# Aberdeen Harbour Expansion Project

**Document Title:** Marine Scotland Act Part 4 Marine Licensing,  
Licence Number: 05964/16/0 Reference No: 05964  
Proposed Variation to Dredging Licence

Subject Dredge Depth & Area Amendments

### Extension of Dredge Depth

Figure 1: Overall Dredge Layout – Comparison of New vs Old

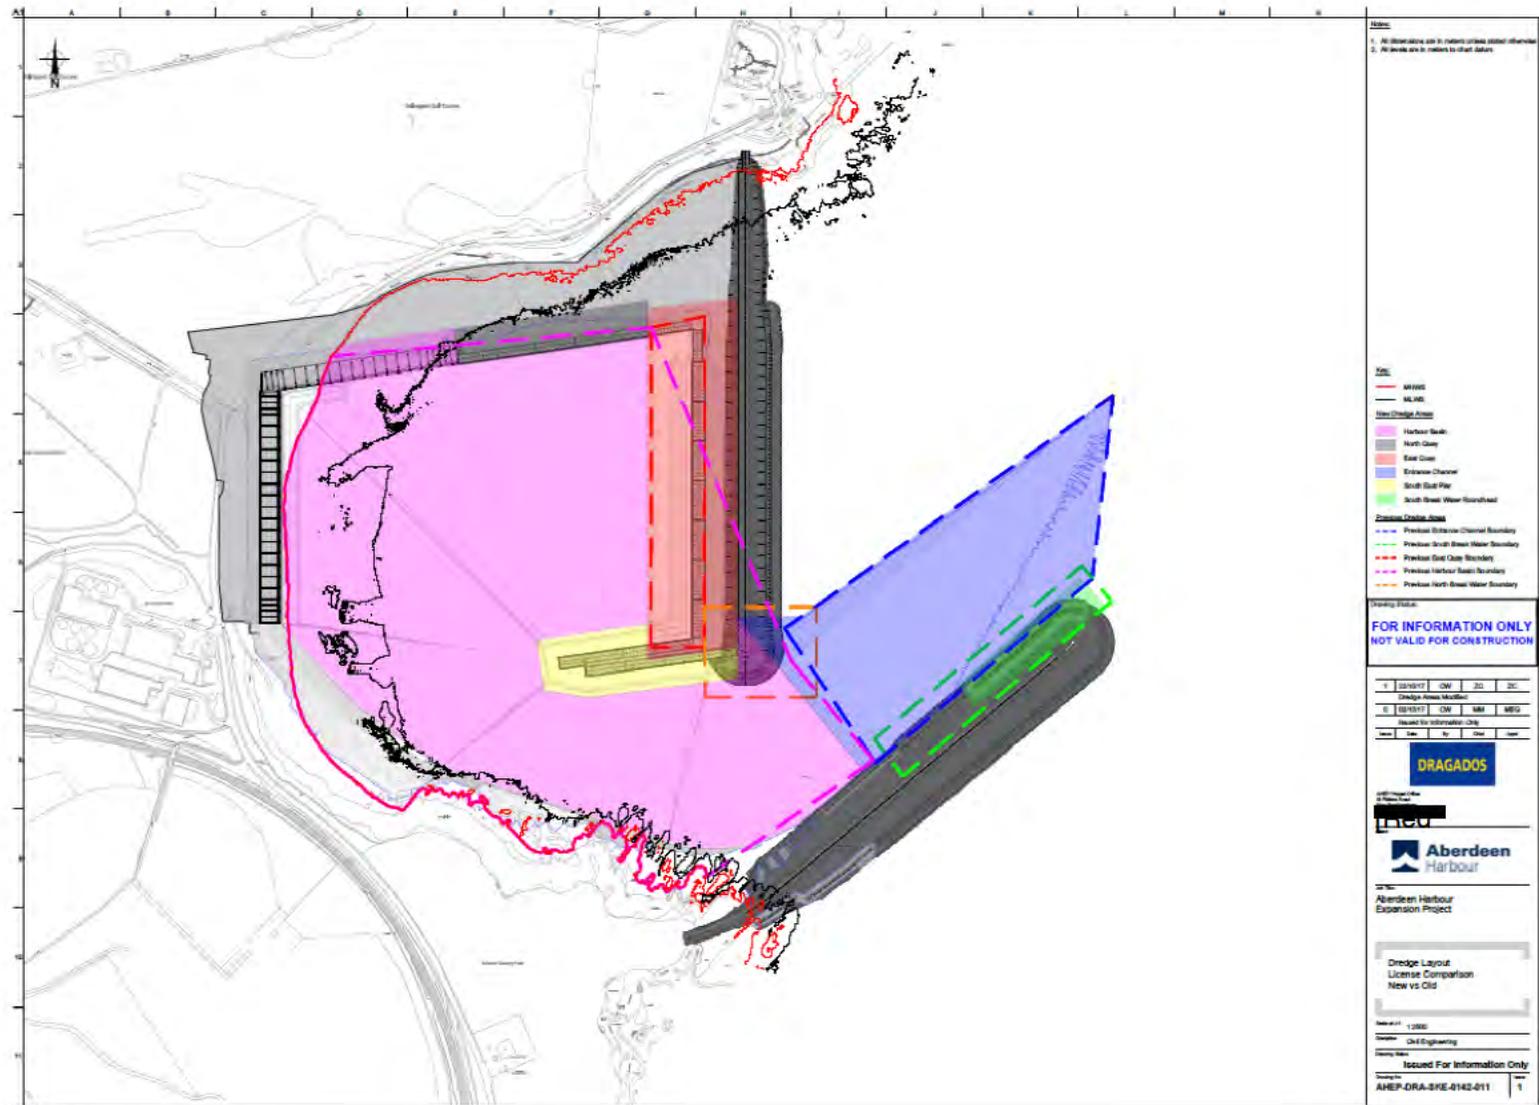
For ease of reference, an overview of the AHEP dredge layout is provided in Figure 1: Overall Dredge Layout. The following variations are proposed to the dredge depths and areas:

- This area will be removed as it is either no longer required or covered by other areas.

Figure 2: Harbour Basin

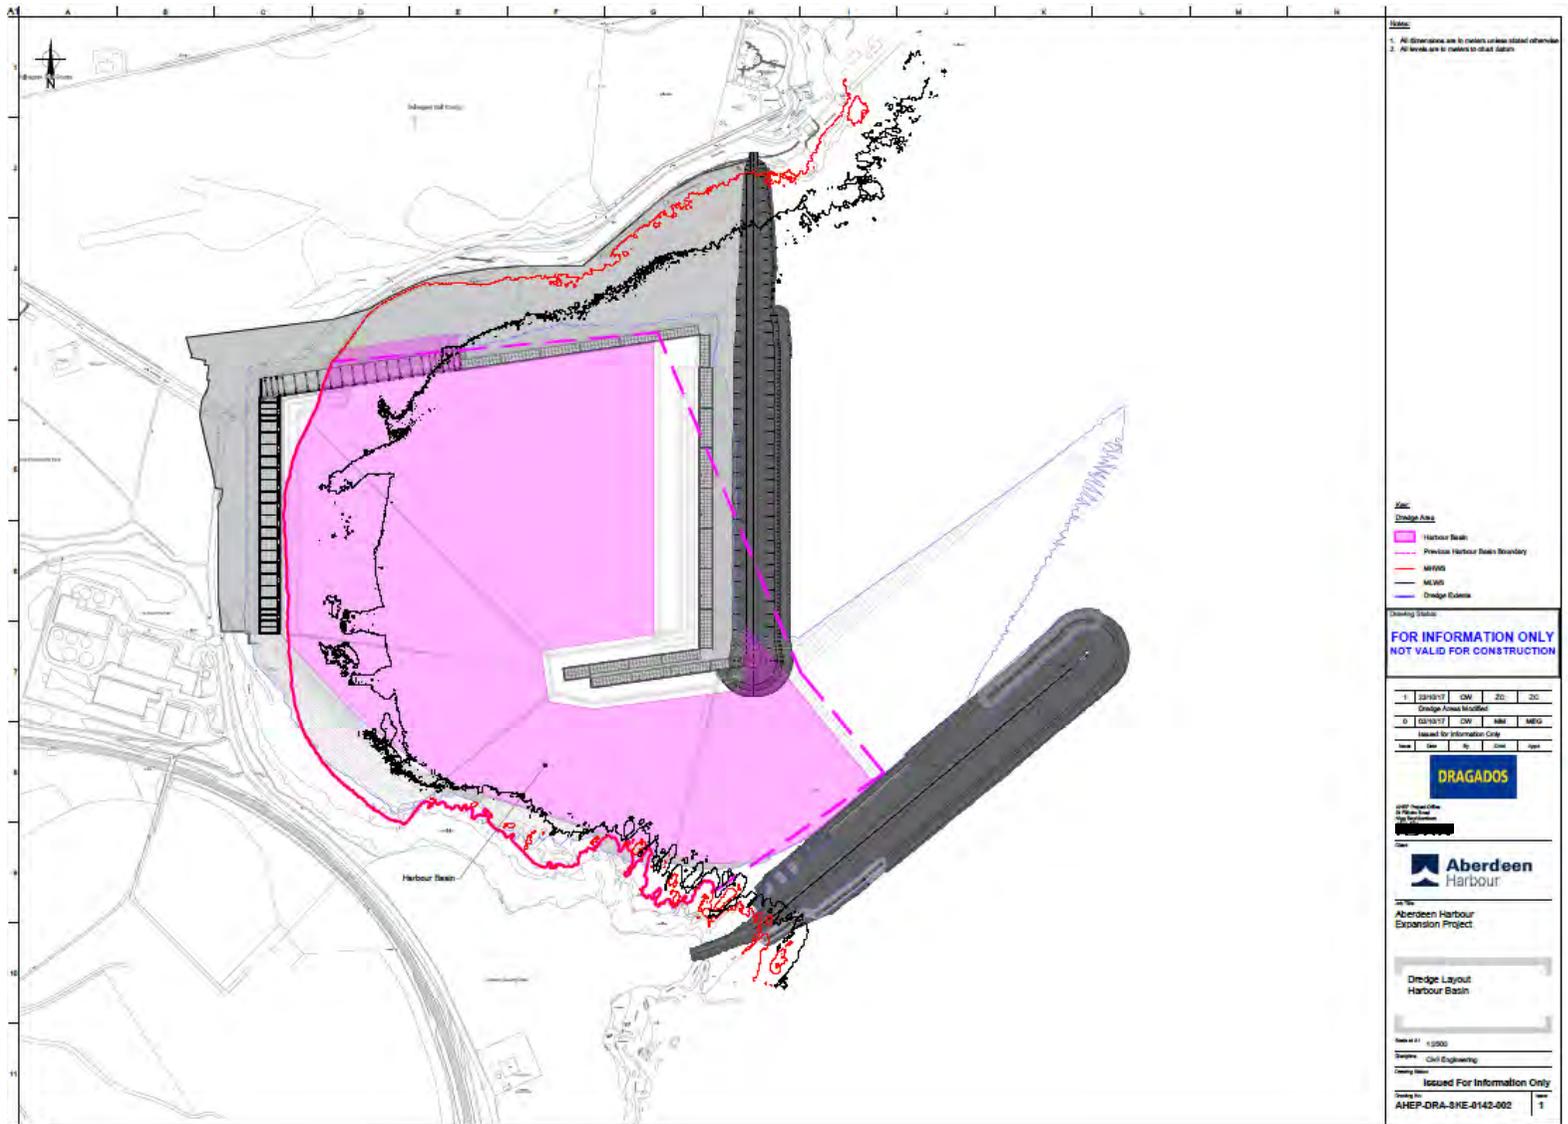
**Harbour Basin** (See Figure 2: Harbour Basin & Figure 3: North Quay)

- There is a minor variation proposed to the Harbour Basin with an extension to the north of the site under the area where caissons will be installed. (North Quay – See Figure 3: North Quay)
- The area under the East quay and South East Pier is removed from the Harbour Basin dredge.

Figure 4: East Quay

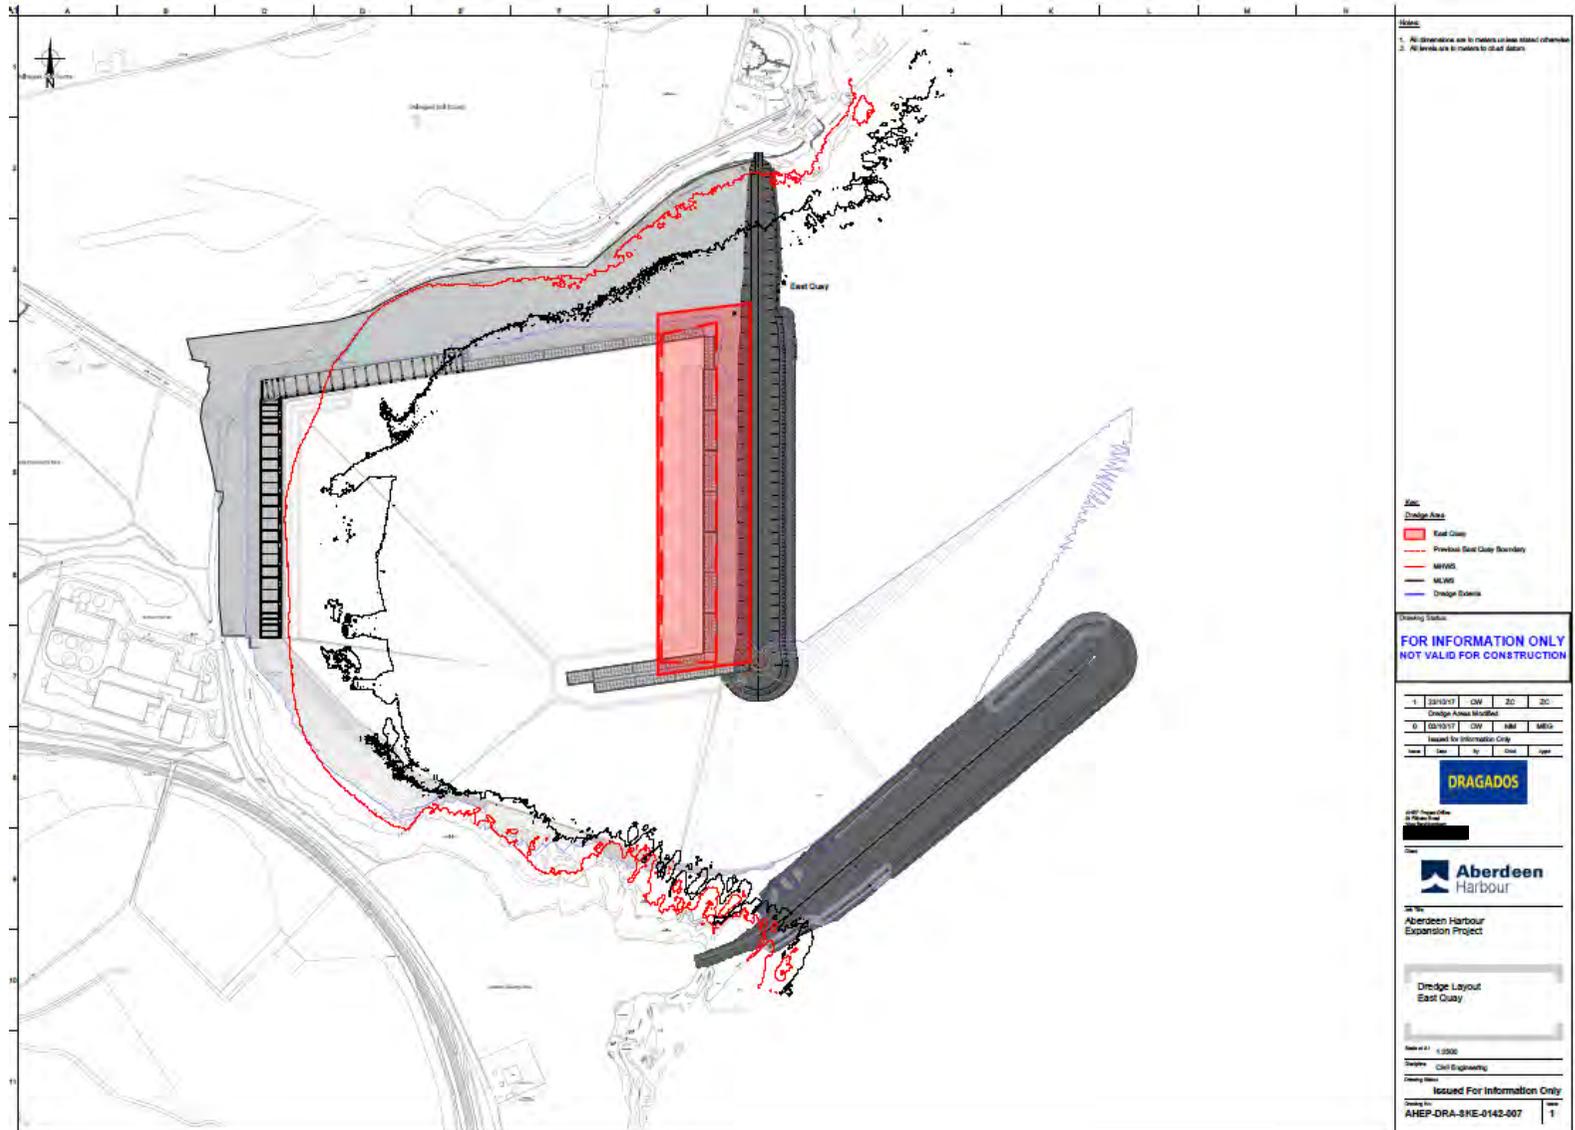
**East Quay & Entrance Channel** (See Figure 4: East Quay and Figure 5: Entrance Channel)

- The East Quay area is extended to incorporate the footprint of the caissons and dredge depth changed to 12.95m
- The Entrance Channel has a minor variation to take into account a small area at the edge of the proposed channel that was previously omitted from the licence.

Figure 6: South East Pier

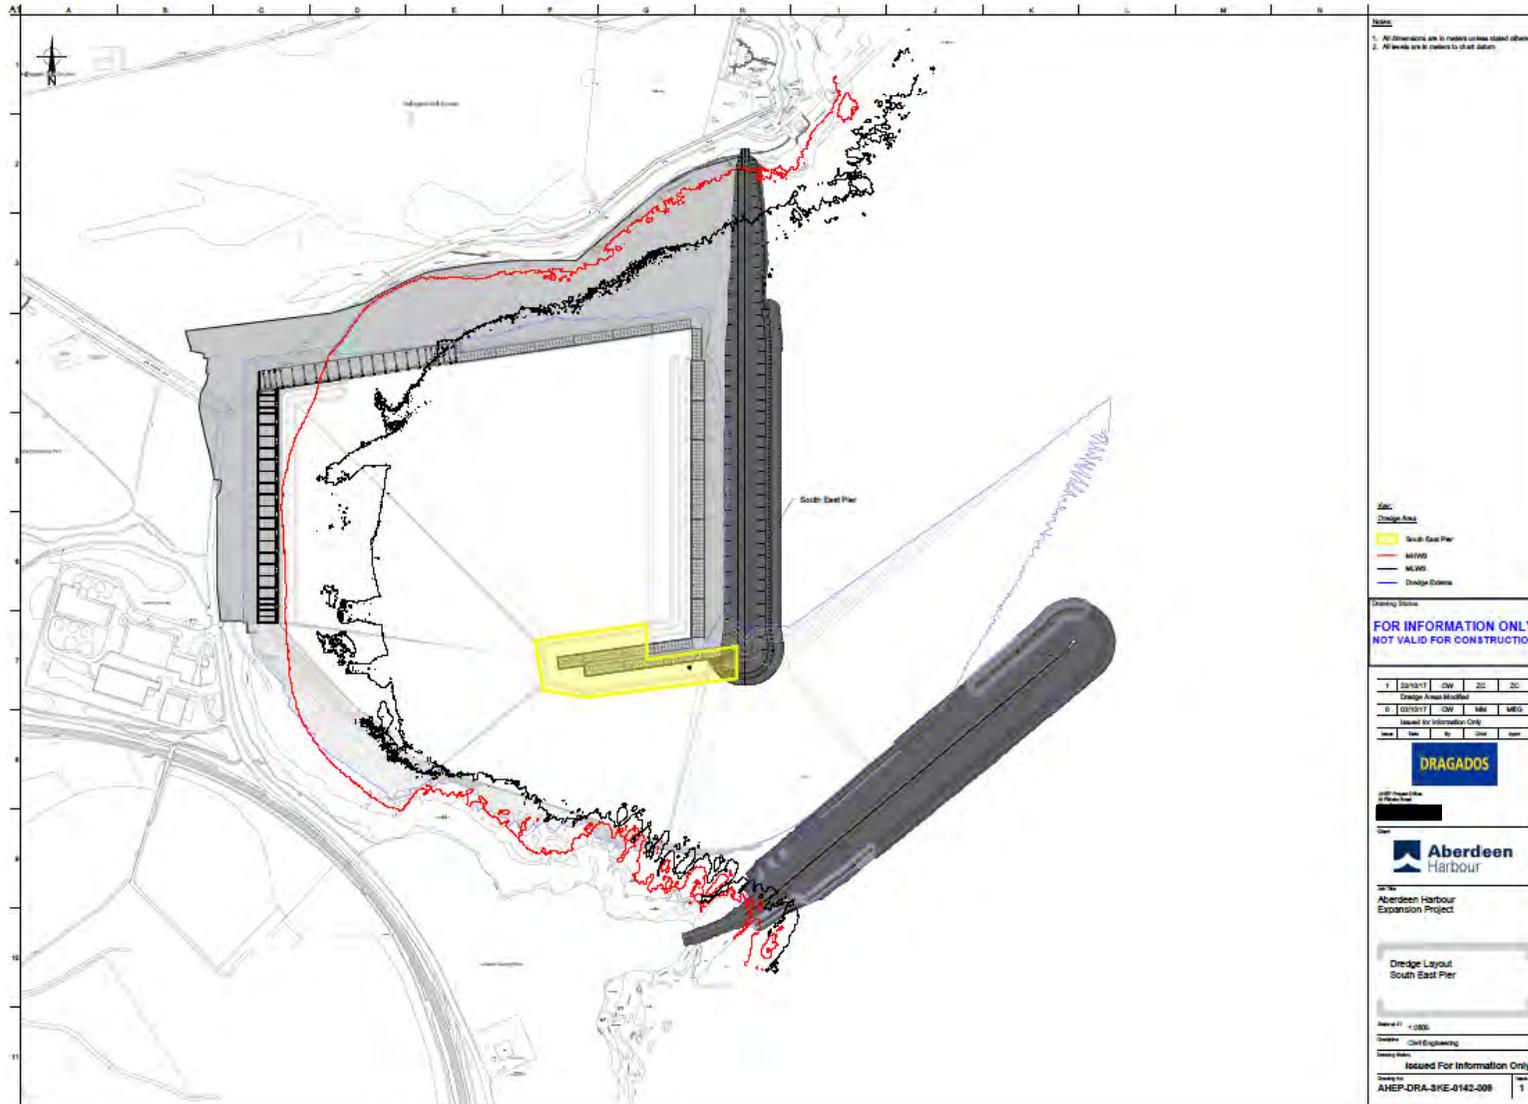
### **South East Pier – New Area (see Figure 6: South East Pier)**

- Dredging of South East Pier to achieve a seabed depth of approximately 11.45m below CD

Drawing Title  
Geological Cross Section 1-1  
South East Pier

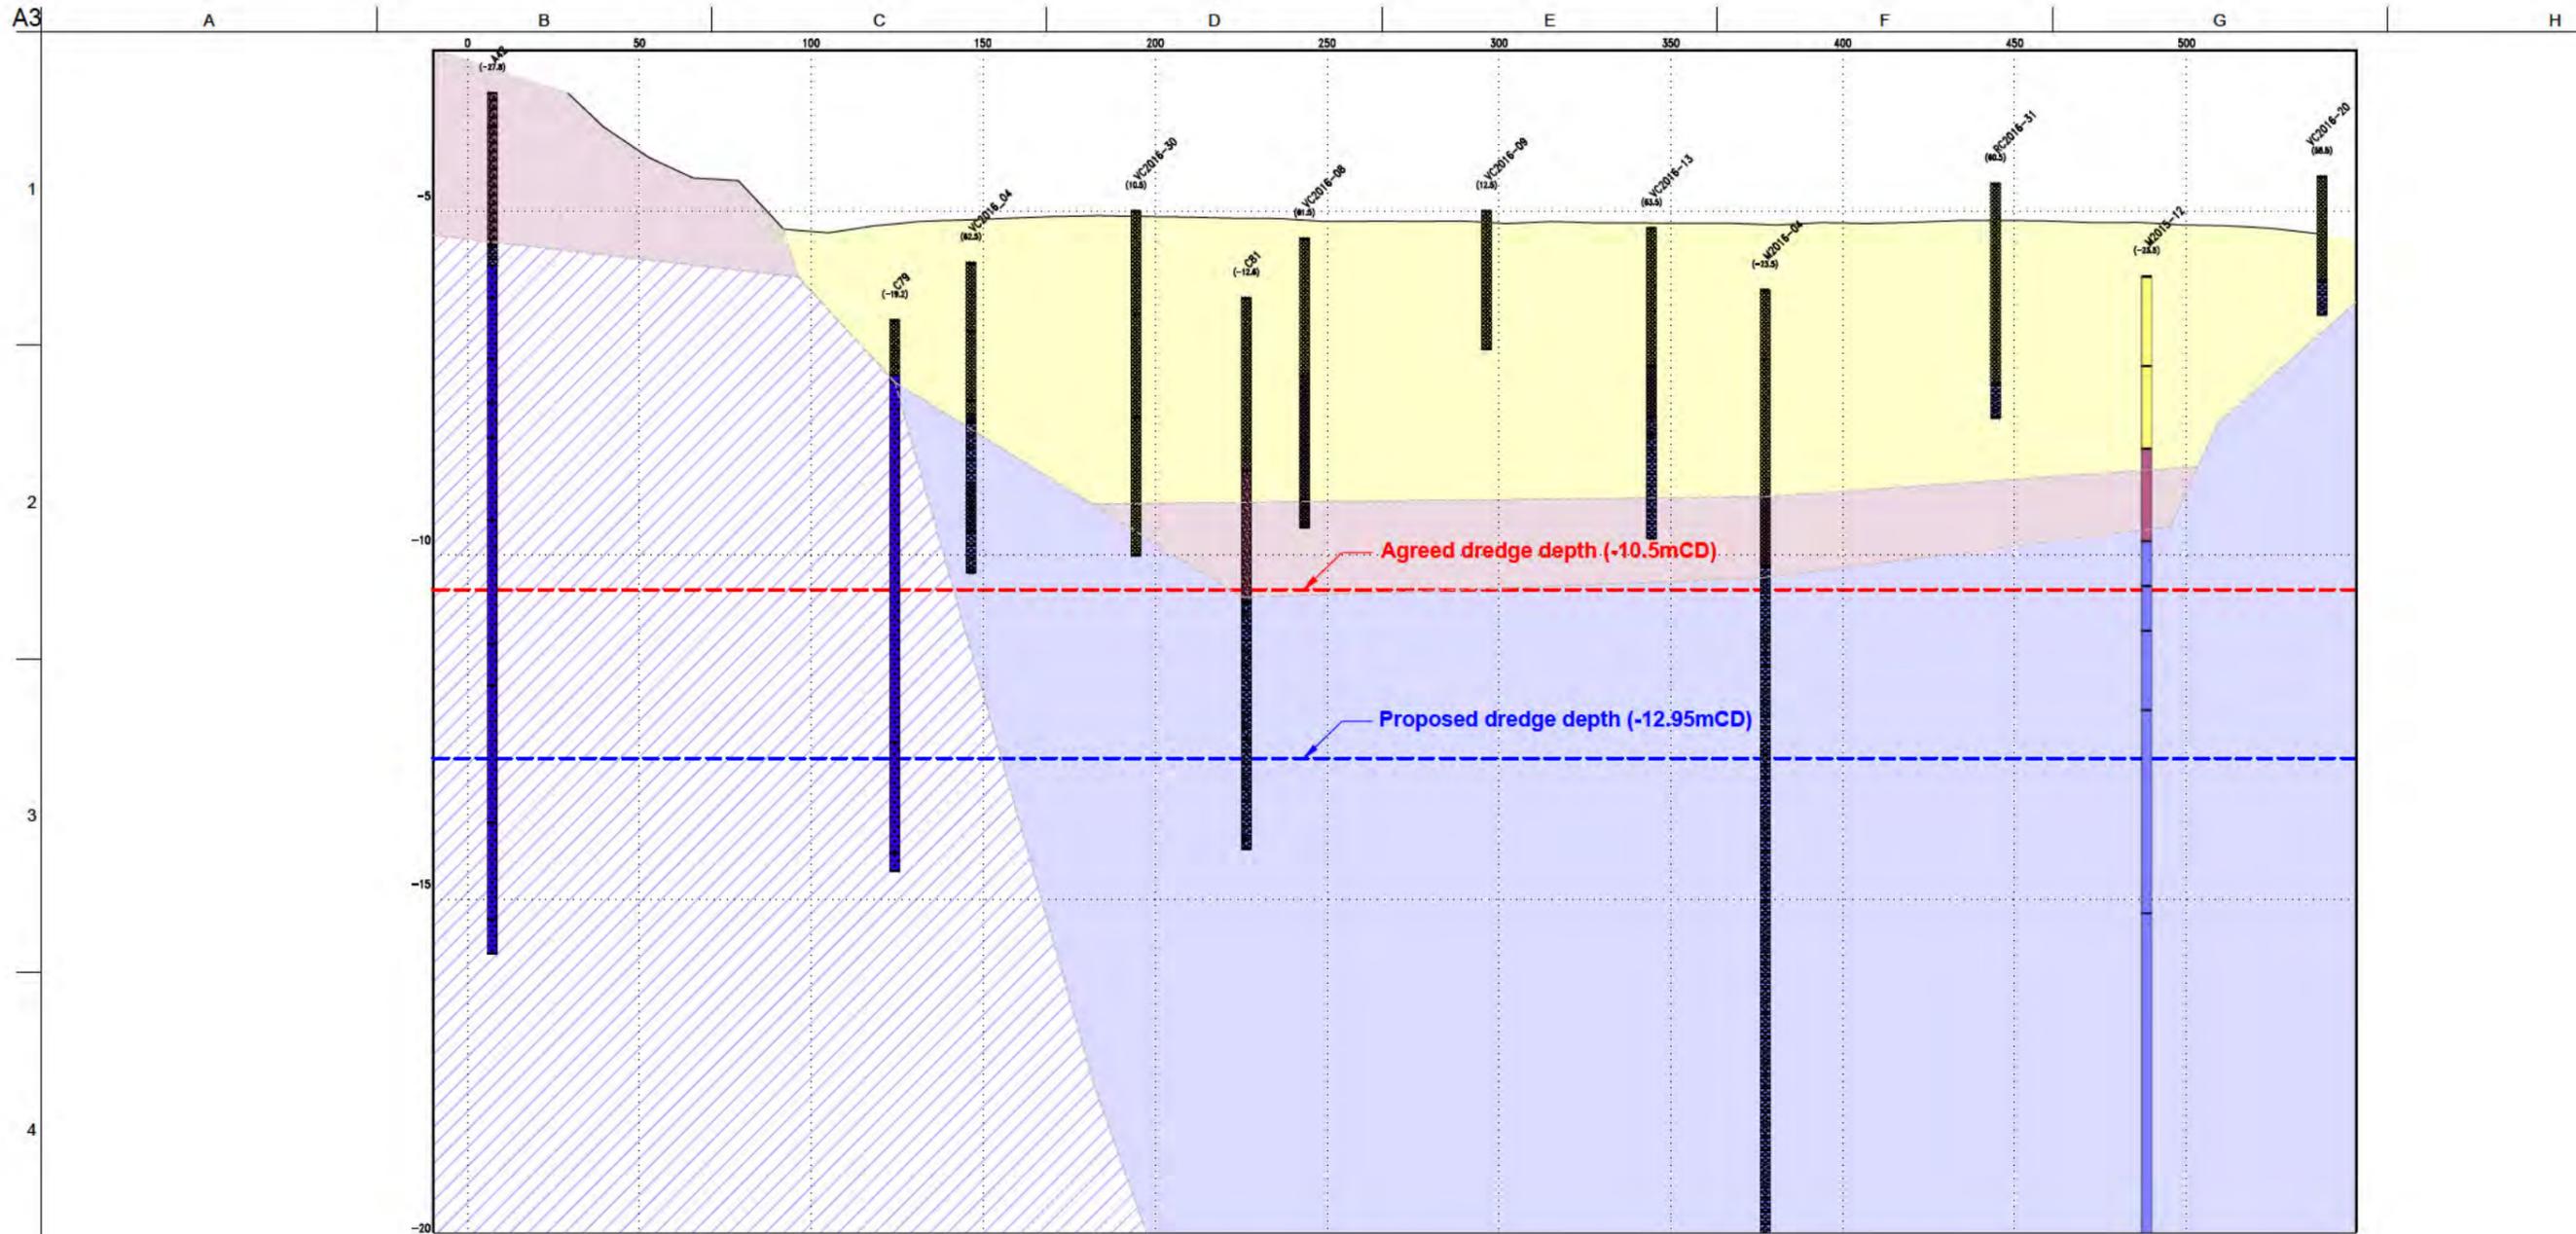
- *Dredging of East Quay. Increase seabed depth of approximately 10.5 metres below CD to 12.95m below Chart Datum (CD).*
- *Dredging of South East Pier. Increase seabed depth of approximately 9.0 metres below (CD) to 11.45m below CD.*

The locations of the ground investigations are shown on Figure 2. Figures 3 and 4 show geological cross sections and the proposed dredge depths at the East Quay and South East Pier.
